PLANNING

**34 Glenilla Road
Belsize Park London**

**Existing Front Garden Plan
Proposed Front Garden Plan**

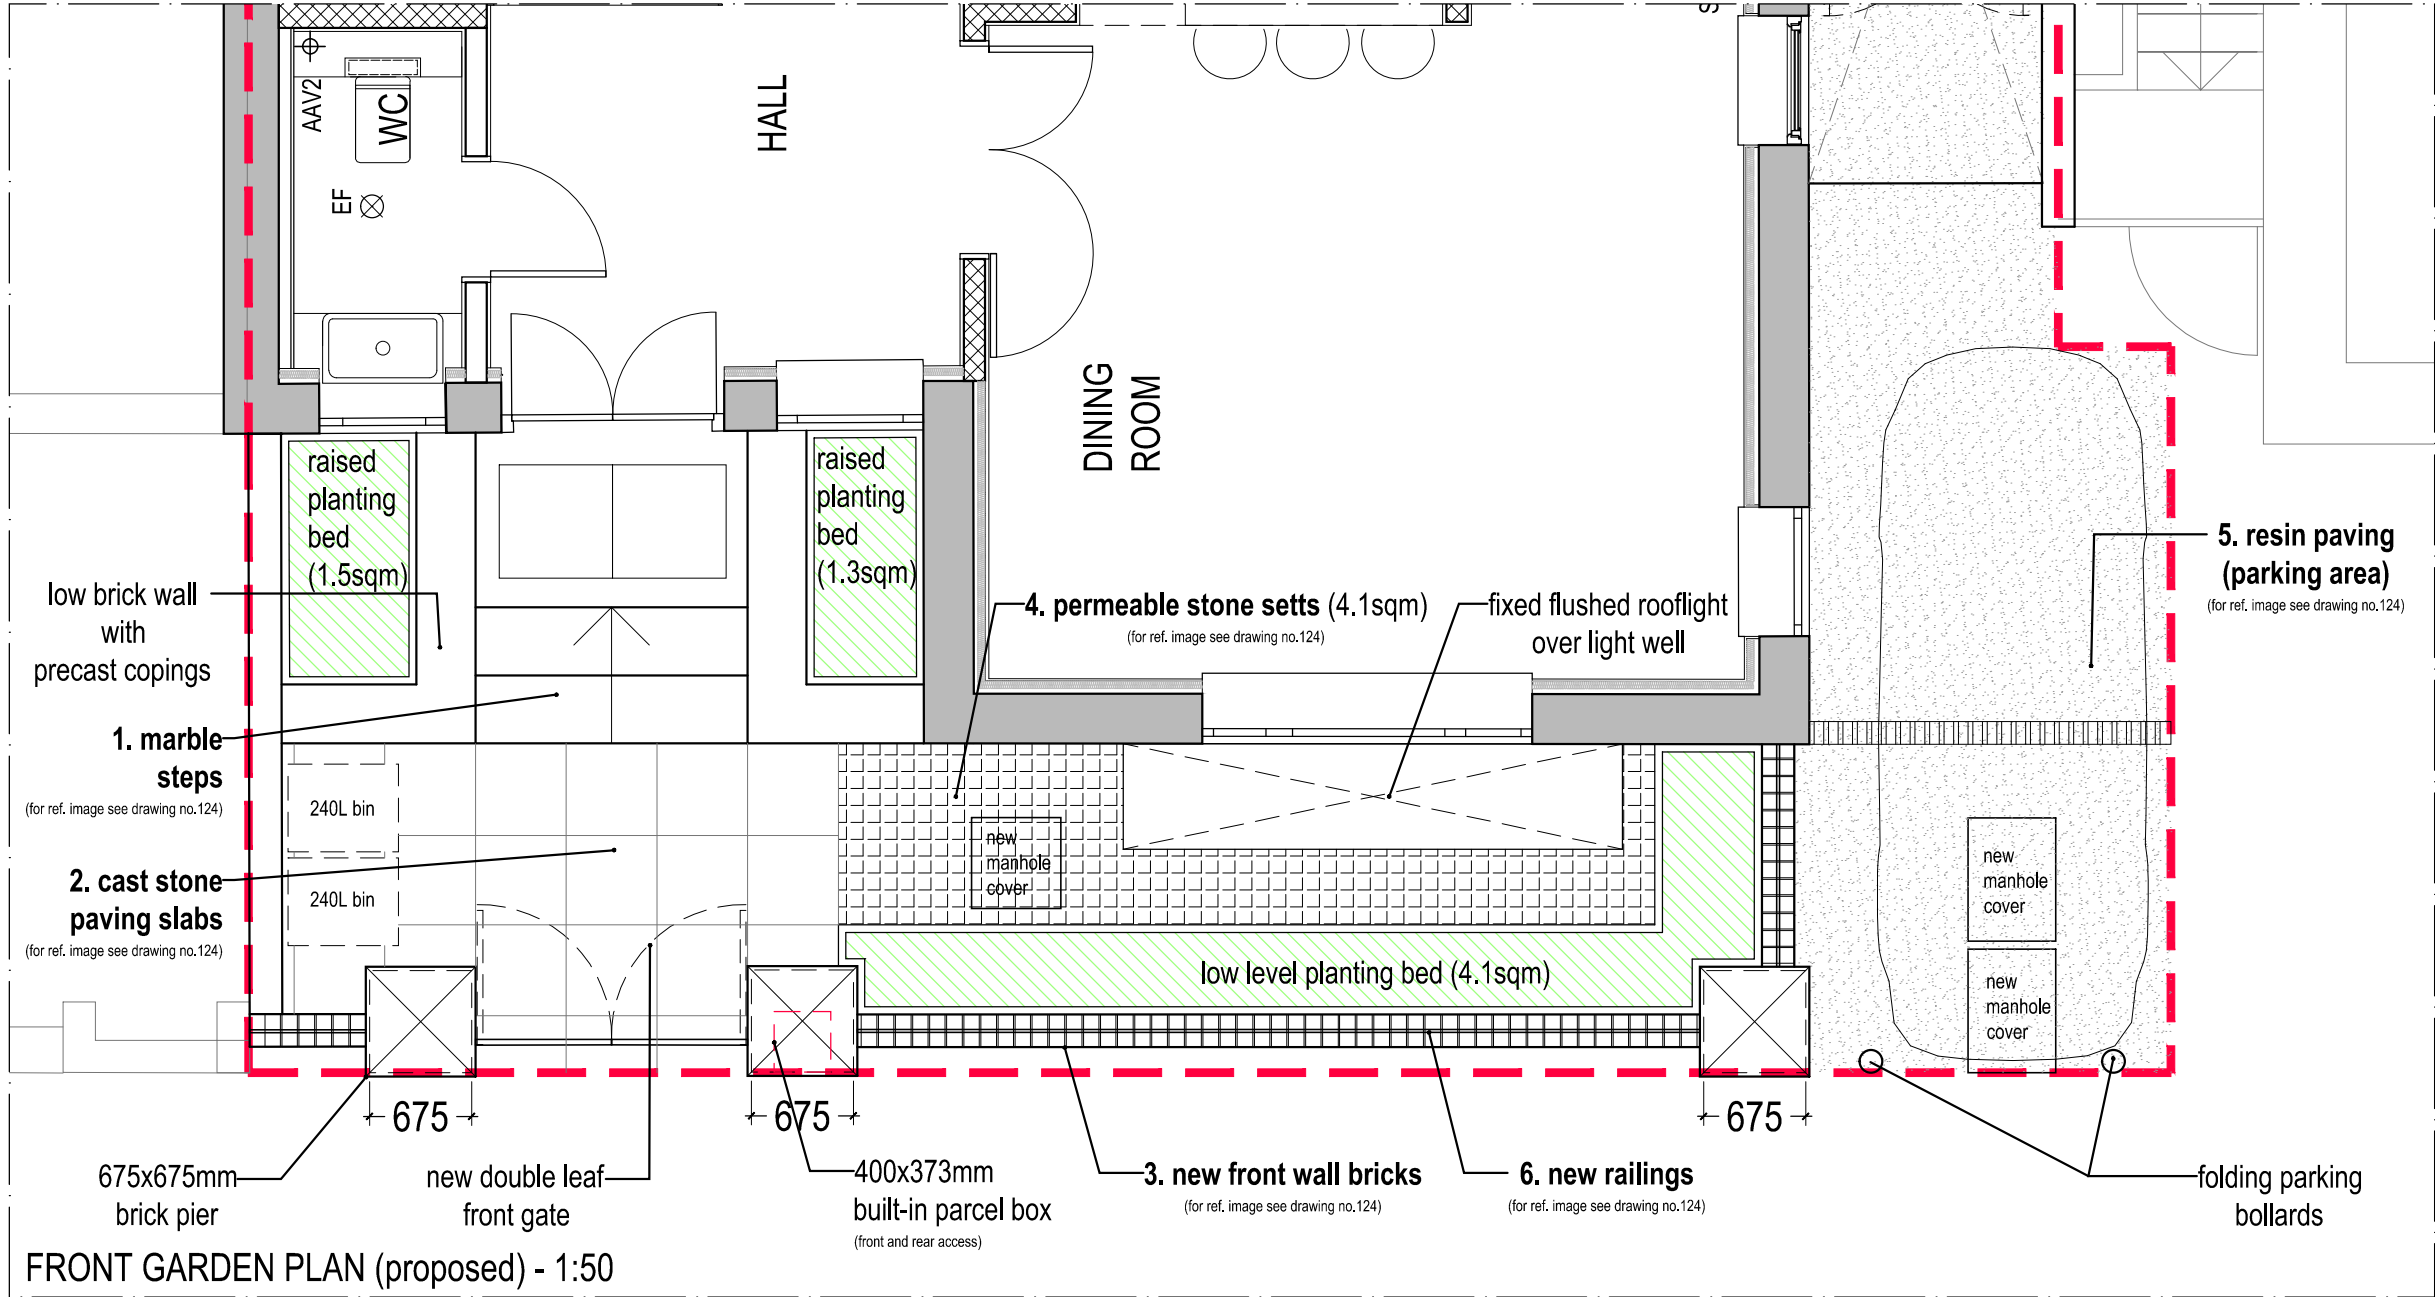
| 02 | Dec21 | Variation of Planning Consent (Comments): - Brick Piers lowered (1250mm) - Bin Position changed - Permeable area improved | DC | RM |
| 01 | 06/08/21 | Variation of Planning Consent (Condition no.3): - Front Garden Renovation - Addition of no.4 Conserv. Rooflights - Removal of no.1 Existing Rooflight | DC | RM |
